**CITY OF RIVERSIDE COUNCIL AGENDA
RIVERSIDE CITY HALL COUNCIL CHAMBERS
60 N GREENE STREET**

Special Meeting

3. Sidewalk at 381 E 4th street

4. Sidewalk on Hickory between Sycamore and Schnoebelen Streets

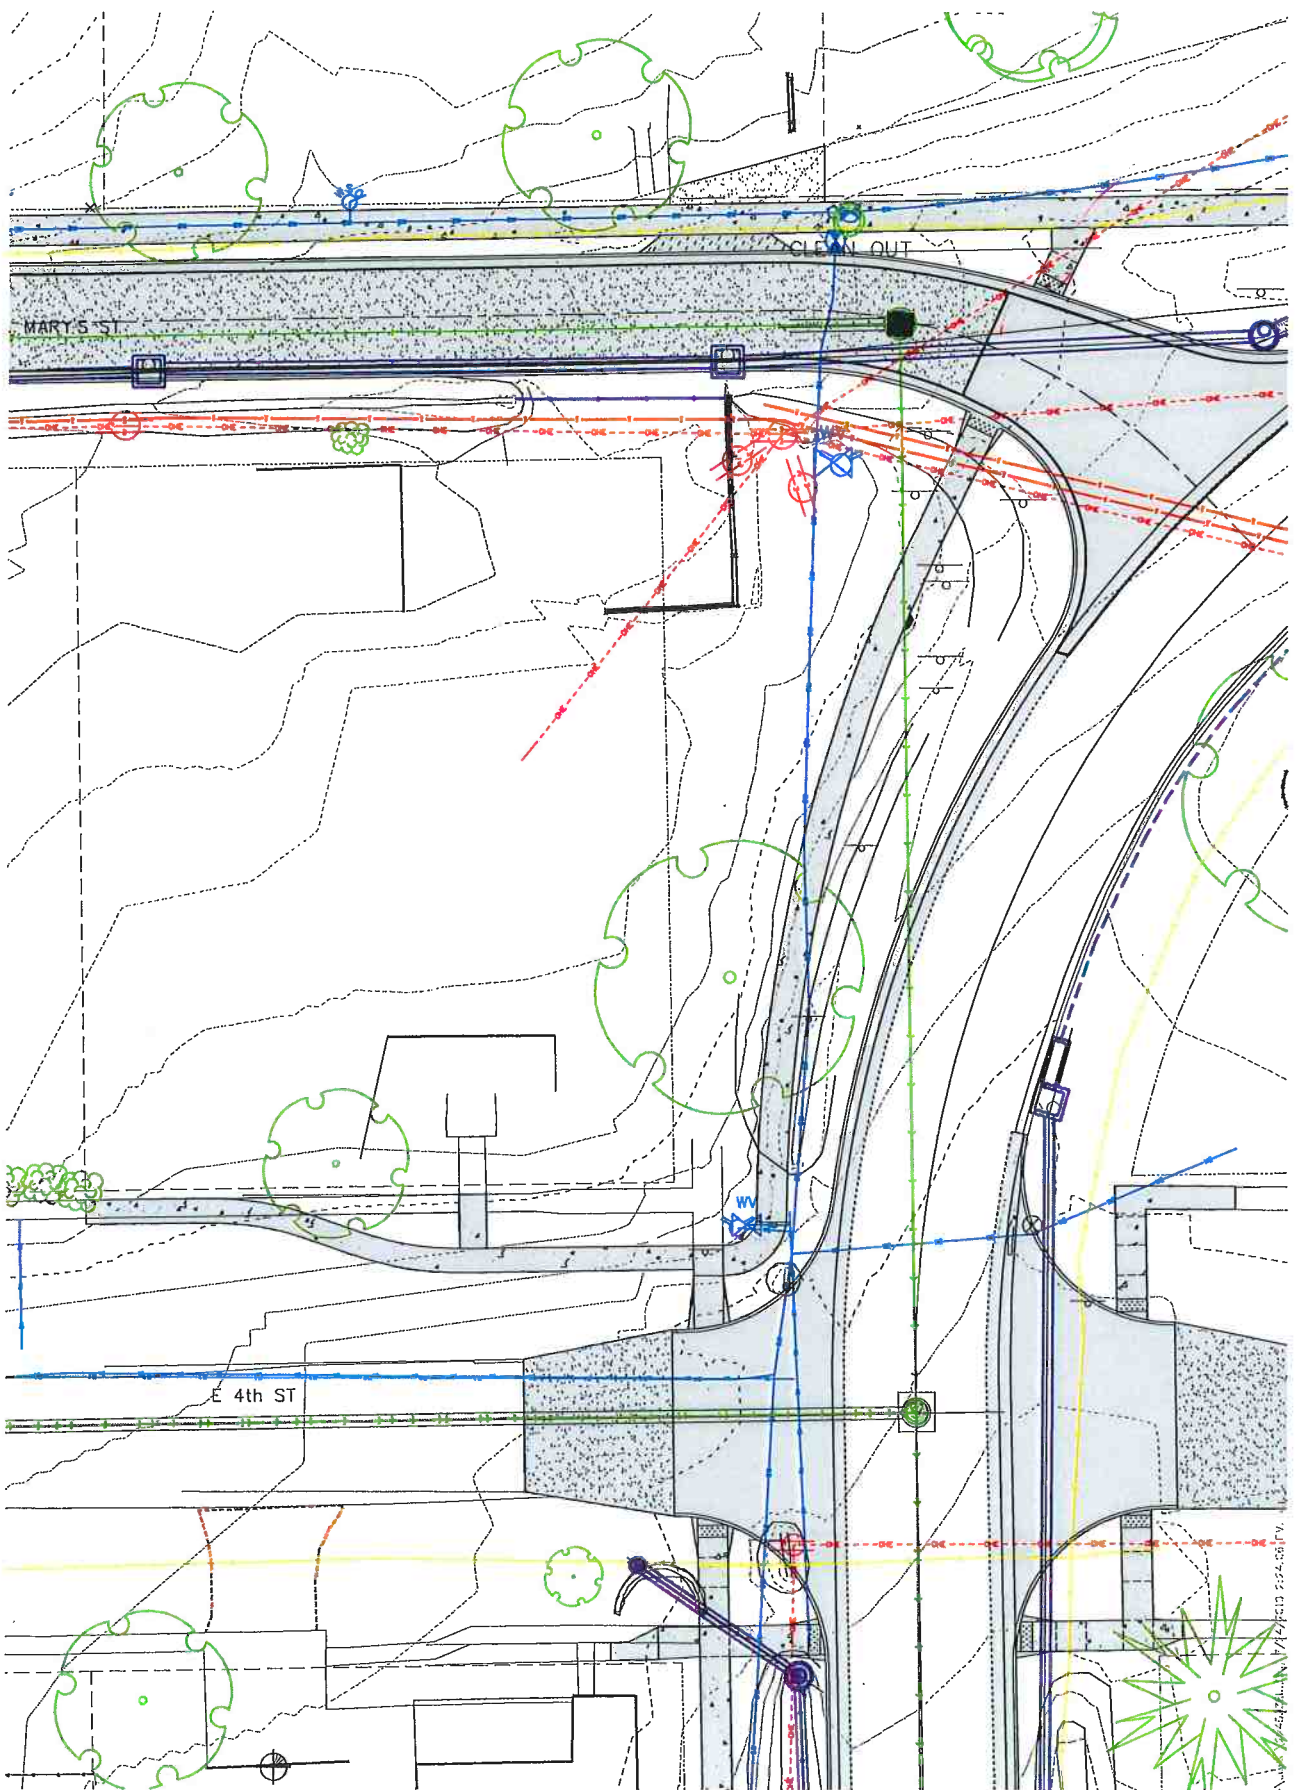
What happens on private property is beyond our jurisdiction unless it impedes highway sight distance from side roads. Please Verify that all of the wall is placed on private property.

There is no justification related to safety or design criteria to support putting in a retaining wall. If this was necessary to meet ADA requirements or to address and protect the clearzone then it would warrant designing and constructing as a justified cost.

After discussion with Jim Armstrong, District Engineer, it has been decided that we do not support a retaining wall constructed in ROW for this area. This area does not warrant a retaining wall for the requested reason so let's not deviate from the current design.

The plans showed grading on to adjacent property in order to make the ADA sidewalks work at the NW corner of Highway 22 and 4th Street. In talking to the adjacent property owner he asked if the City could build a retaining wall instead. The reason is that he has had vehicles leave the roadway through the curve in the past and end up in his yard and home. He felt the slope up from the sidewalk almost was like a ramp if a vehicle did leave the roadway again and that a wall may help protect his home if that happened.

Attached is a preliminary design of a wall at this location. The City Council is OK with a wall at this location. I wanted to reach out to you to make sure the DOT was OK with a wall at this location. A portion of the wall would be within the ROW so I assume would require permission from the DOT.

Please review the attached and let me know if this would be OK. Let me know if you need additional information.

SYCAMORE STREET

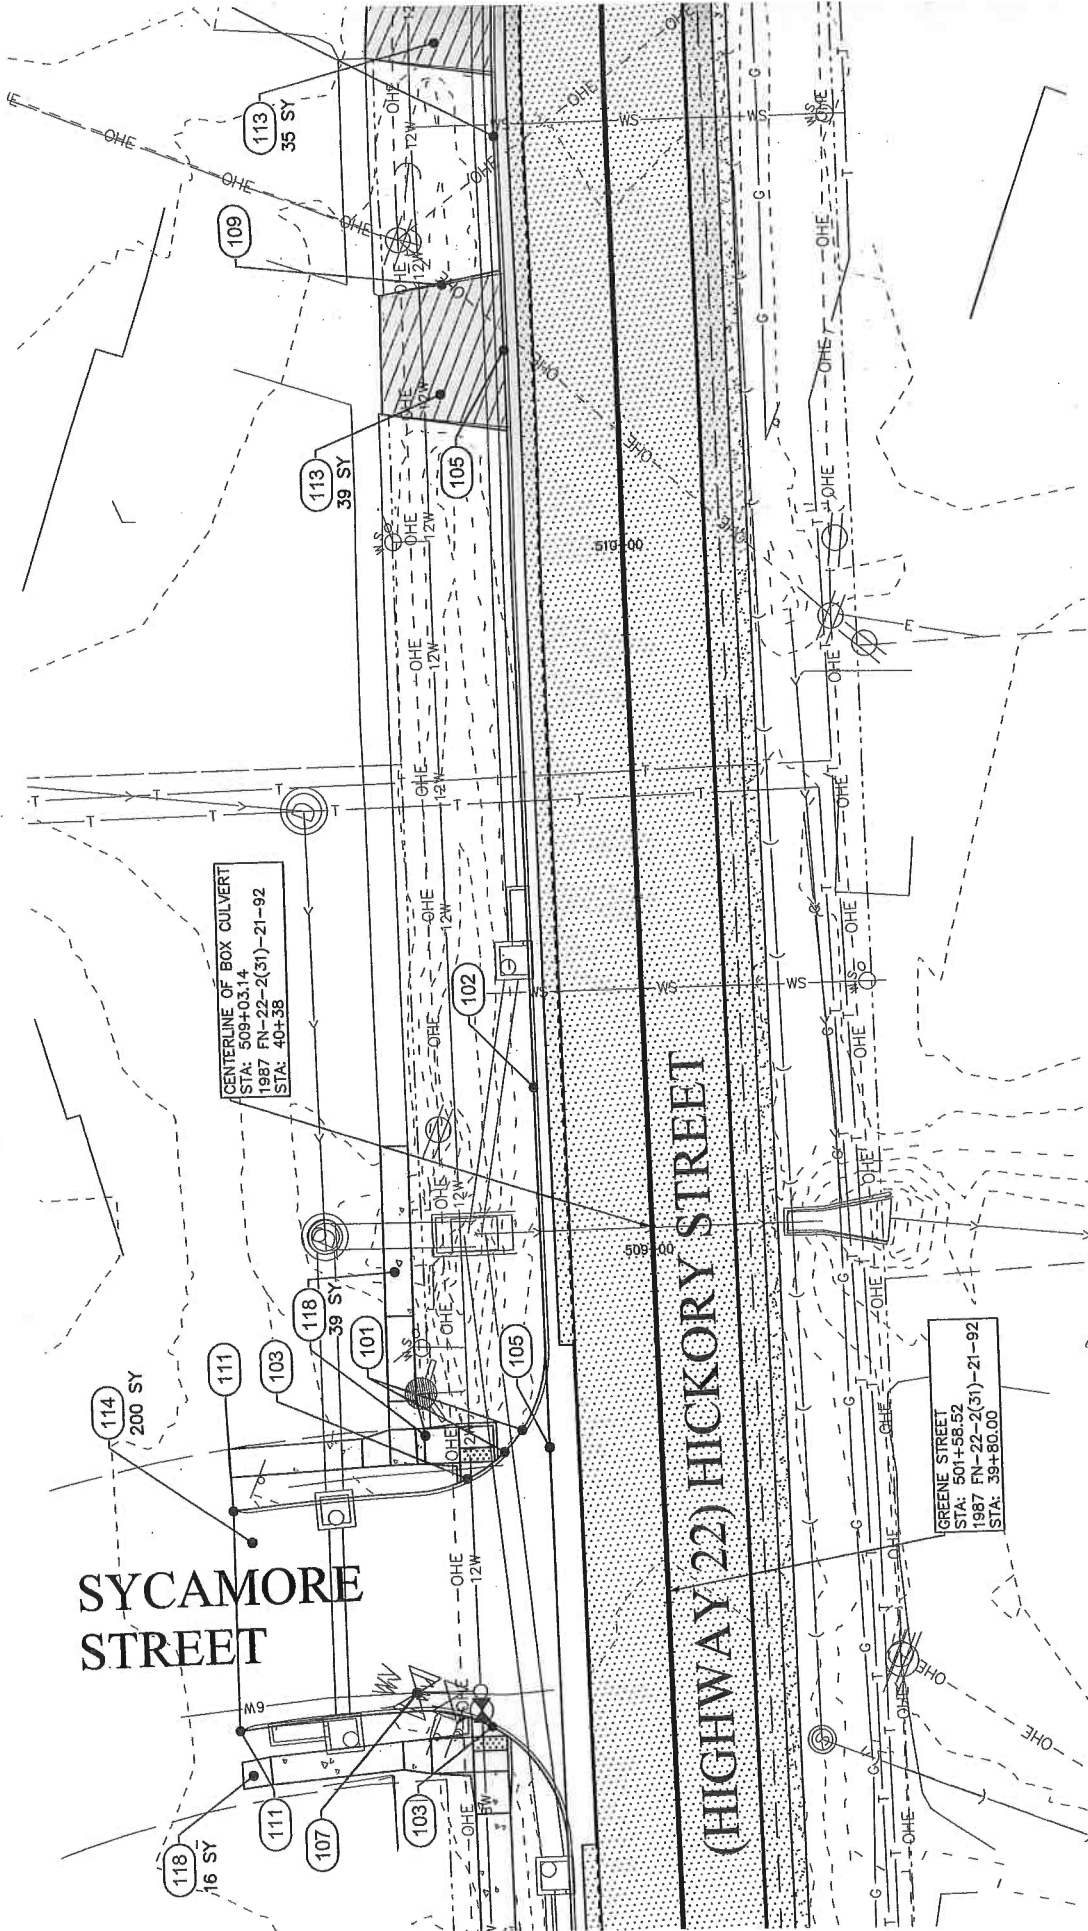
Right now the plans show replacing the westerly 40 feet of this sidewalk (the area of the bridge) with 4' wide sidewalk. There is an additional 288 feet to Schnoebelen. The cost to replace the remaining 288' at 4' wide is:

128 SY Sidewalk Removal \$8/SY - \$1,024.00
128 SY 4' Rock Base \$6/SY - \$768.00
128 SY 5" PCC Sidewalk \$39/SY - \$4,992.00
Total \$6,784.00

The cost to replace the whole length to 5' wide is as follows (would include replacement of curb ramp at Schnoebelen Street):

135 SY Sidewalk Removal \$8/SY - \$1,080.00
172 SY 4' Rock Base \$6/SY - \$1,032.00
172 SY 5" PCC Sidewalk \$39/SY - \$6,708.00
10 SF Detectable Warnings \$30/SF - \$300.00
Total \$9,120.00

The plans already show paving the two driveways between the sidewalk and the new curb and gutter.
